EARLY GRADING AND EROSION CONTROL PLANS SPRINGS AT WATERVIEW

EL PASO COUNTY, STATE OF COLORADO

DSE Dakota Springs Engineering
31 N. TEJON, SUITE 500
COLORADO SPRINGS, CO 80903
P: (719) 227-7388
F: (719) 227-7392
PROJECT SPRINGS AT WATERVIEW
SHEET TITLE TITLE SHEET
FROM _____ TO _____
JOB NO. 01021 SHEET 1 OF 6

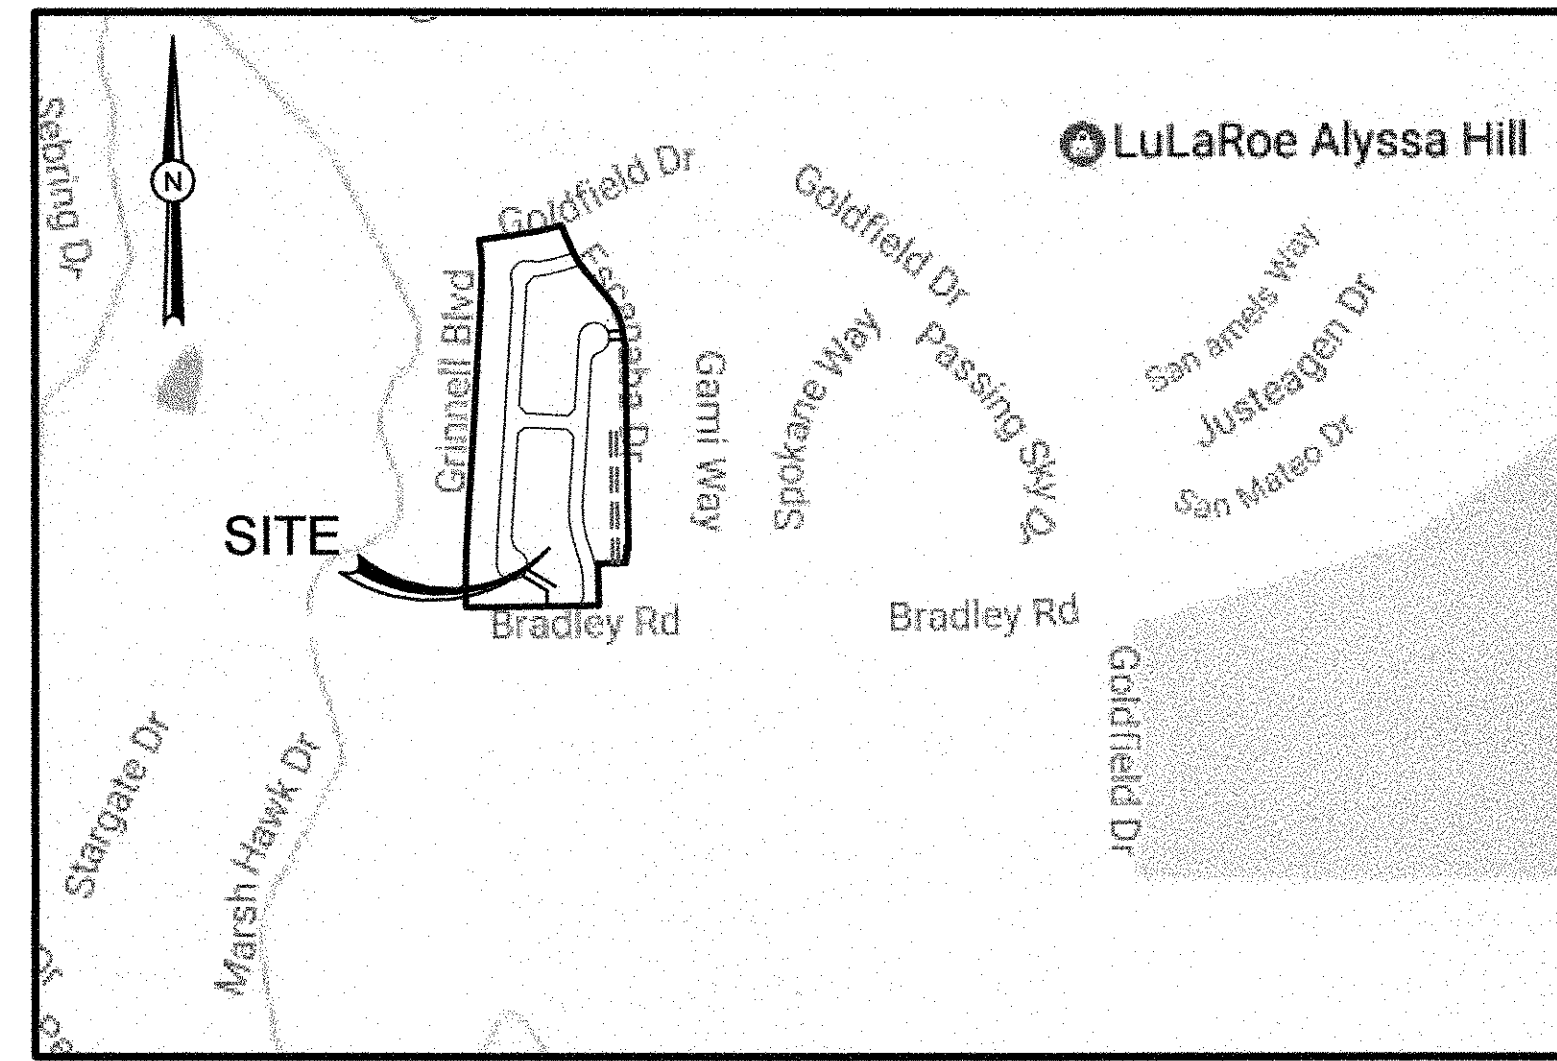
Revise header to 'El Paso County' Unresolved.

Revise header to "El Paso County"
Unresolved.

Sediment Basin (SB)

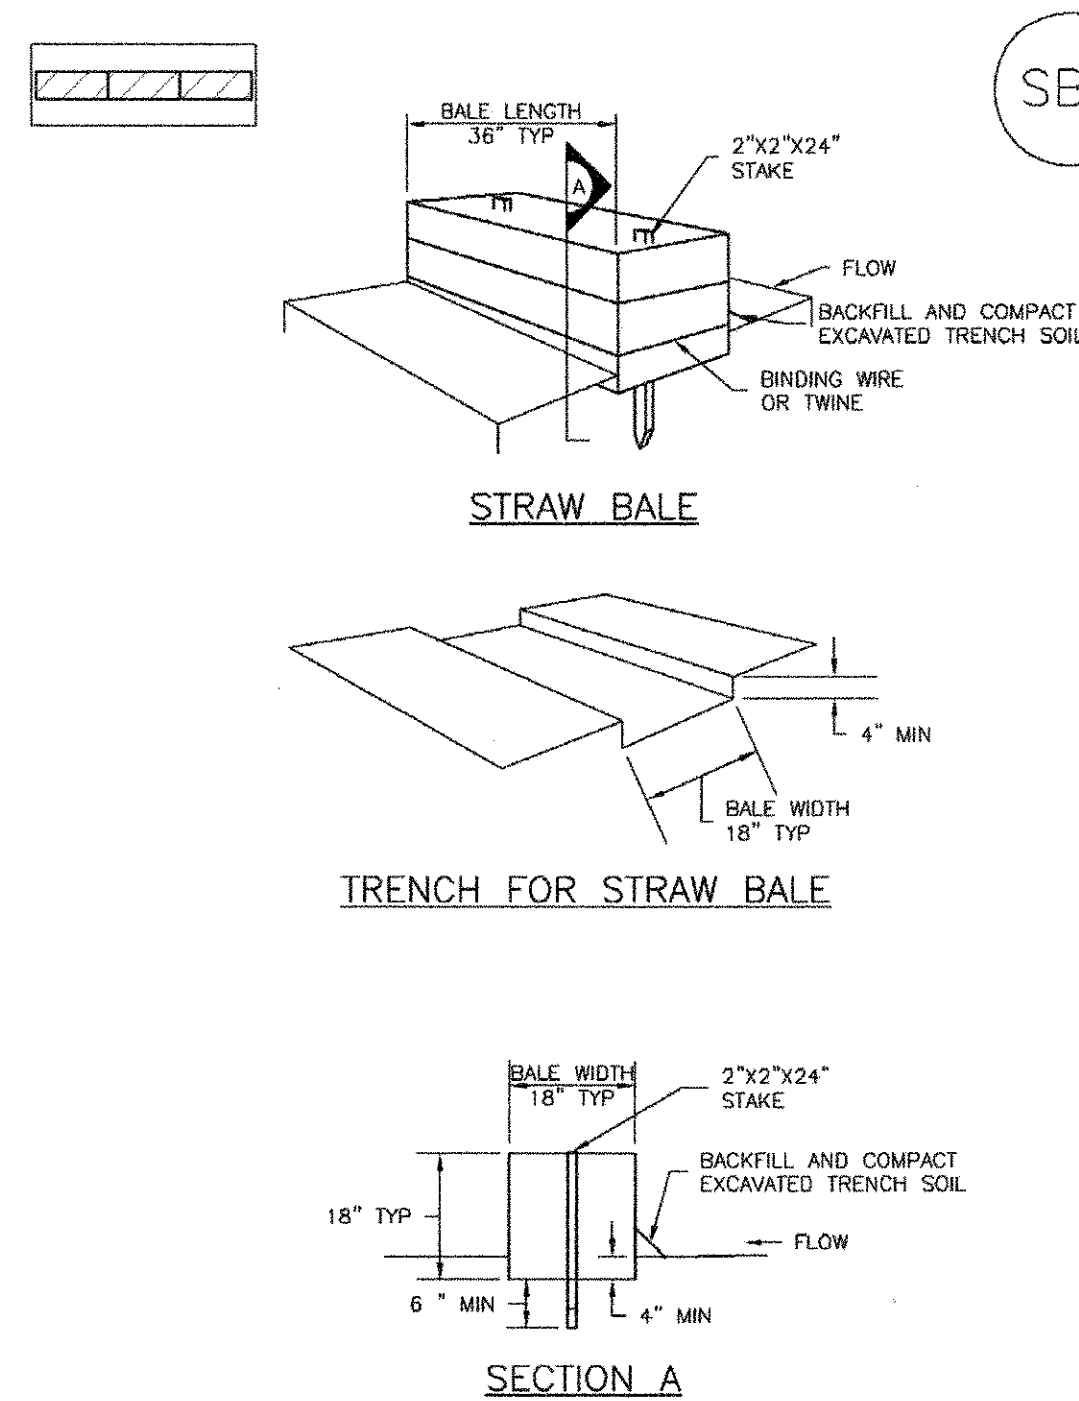
Remove the table and identify the actual required sizing for this temporary sediment basin to be constructed.
 Unresolved. Identify on the plan view or the detail the required orifice hole diameter for the riser pipe. Additionally, show the riser pipe and outfall layout on the plan view

Remove the table and identify the actual required
sizing for this temporary sediment basin to be
constructed.
Unresolved. Identify on the plan view or the
detail the required orifice hole diameter for
the riser pipe. Additionally, show the riser
pipe and outfall layout on the plan view.
